**PUBLIC INTEREST REVIEW FOR GROUNDWATER APPLICATIONS**

TO: Water Rights Section Date October 6, 2014  
 FROM: Groundwater Section Jen Woody  
 SUBJECT: Application G- 17604 Reviewer's Name Supersedes review of: 6/3/2014, 7/10/2013 (by Marc Norton)  
 Date of Review(s)

A. **GENERAL INFORMATION:** Applicant's Name: NF Land LLC County: Umatilla

Figure 1. Hydrographs of nearby wells in the Columbia River Basalt. Most show a downward trend.

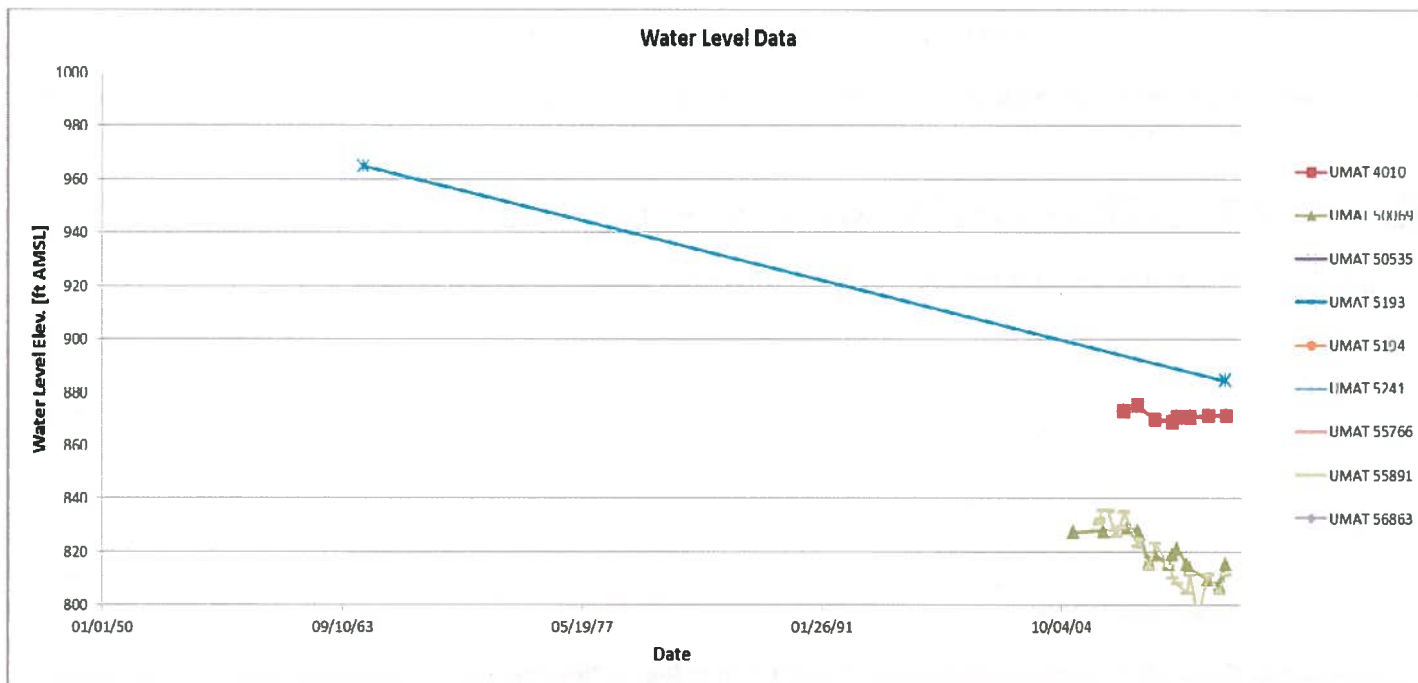
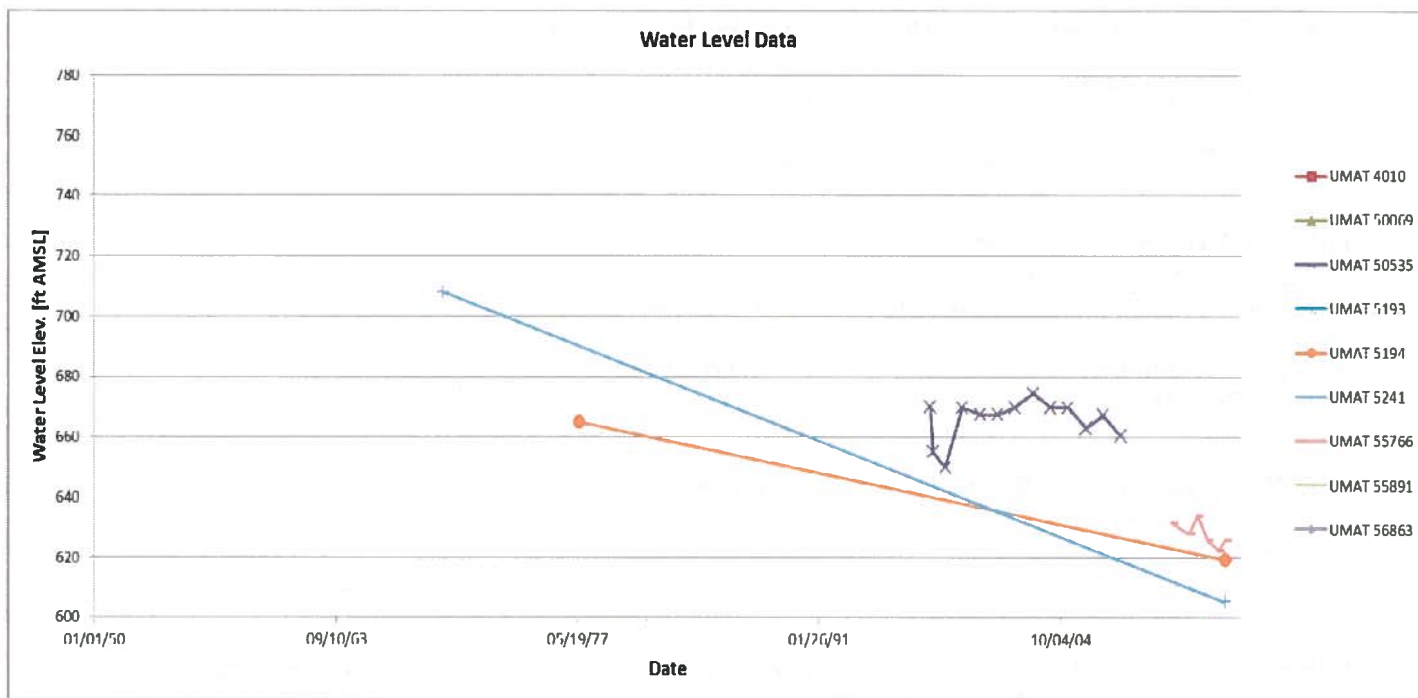
- B3. **Groundwater availability remarks: The applicant is requesting 6.47 cfs (2900 gpm) from 15 wells for irrigation of 517.7 acres. Wells 1 – 15 are PROPOSED. Wells 1 - 7 are located outside of the five-mile radius from City of Milton-Freewater wells and wells 8 – 15 are within the five-mile radius. Aquifers within the Columbia River Basalt Group are capable of producing 2,900 gallons per minute in many areas of the Umatilla Basin. However, these same aquifers often cannot sustain that amount of development without persistent groundwater level declines occurring. Declines have been documented in basalt aquifers in the Umatilla Basin and in the Walla Walla sub-basin. An example would be UMAT 55891, a well located about 6 miles to the north, that develops water from an aquifer in the Columbia River Basalts. See attached map and hydrograph. UMAT 55891 is the POA for permits G-15862 and G-16445. The permits are for irrigation of 104.7 and 104.9 acres respectively. Use of the well began in 2008. From February 2008 to February 2013, the groundwater level has declined 24 feet. Average pumpage was 1.7 acre-feet per acre for the first couple of years as only half of the land was irrigated. The groundwater resource may not sustain the requested duty requested by this application, so decreased total duty is being suggested. This downward trend is not unique to UMAT 55891; groundwater levels in many other wells in the area also show significant decline.**

Figure 4. City wells' open intervals are separated vertically by at least 100 feet from the proposed wells.

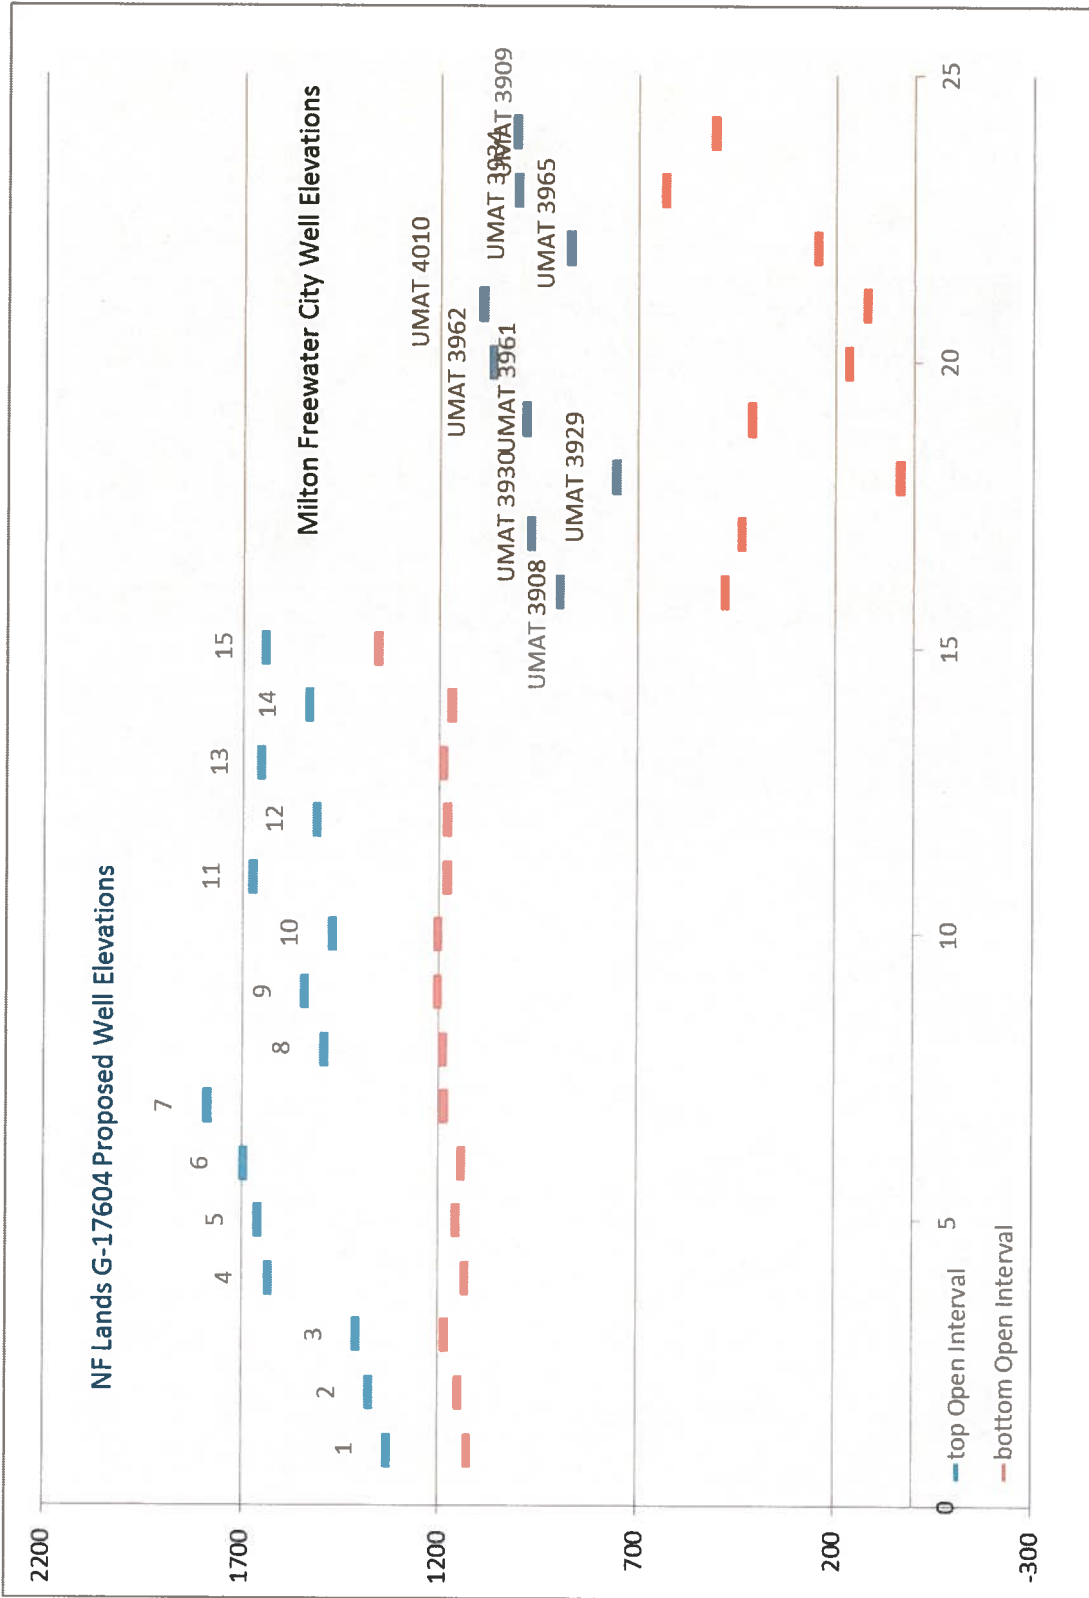
A6.  Well(s) # \_\_\_\_\_, \_\_\_\_\_, \_\_\_\_\_, \_\_\_\_\_, \_\_\_\_\_, tap(s) an aquifer limited by an administrative restriction. Name of administrative area: Umatilla Basin – Walla Walla River Subbasin five-mile radius for wells in basalt aquifers  
 Comments: **ALL WELLS ARE PROPOSED. Wells 1 - 7 are located outside of the five-mile radius from City of Milton-Freewater wells. Wells 8 – 15 are within the five-mile radius from City of Milton-Freewater wells. Proposed wells have open intervals that are vertically separated from the City Wells, indicating they will access a different aquifer. See Figure 4. Proposed wells’ bottom of open interval should be above 1100 feet msl to maintain separation from City wells.**

- B2.
- a.  Condition to allow groundwater production from no deeper than a bottom hole elevation of 1,100 feet.;
  - b.  Condition to allow groundwater production from no shallower than \_\_\_\_\_ ft. below land surface;
